<b>Subject</b>	<b>Meeting Minutes - Citizen Advisory Group (CAG) Meeting #8</b>
<b>Meeting Date</b>	<b>March 29, 2017</b>
<b>Scheduled Time</b>	<b>6:00 pm – 8:00 pm ET</b>
<b>Location</b>	<b>215-217 Liberty Street, Little Ferry, NJ 07643</b>
<b>Attendees</b>	<b>Attendee list available; <i>for internal use only</i></b>

# REBUILD BY DESIGN MEADOWLANDS

## CITIZEN ADVISORY GROUP (CAG) MEETING #8

### ALTERNATIVE 1: STRUCTURAL FLOOD REDUCTION CONCEPT DEVELOPMENT

## SCREENING THE SOUTHEAST OPTIONS

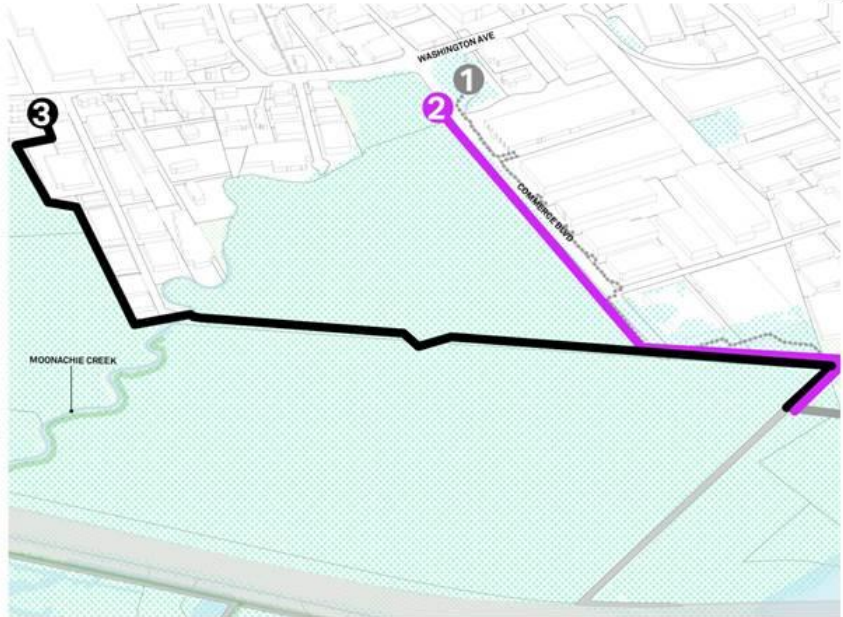
- Following the completion of the presentation, the CAG Members posed the following questions and comments:
  1. In reference to Southeast Option 3 along Commerce Boulevard, it would be great to see this extended to follow the Kane Mitigation dike to the turnpike. This would strengthen the dike, provide an opportunity to improve freshwater forested wetlands in this area, provide additional wetlands mitigation credit opportunities for local projects (e.g., the Teterboro Airport projects), and minimize the chance of a *Phragmites* fire. Fuel loads within these *Phragmites* stands have a tendency to build up (e.g., 5 years ago they caught fire and the nearby buildings almost burned down). Also, please note that for Southeast Option 2, there are large boulders along the road due to construction that occurred 20 to 30 years ago.

*Response: The RBDM Project Team will take this into consideration.*
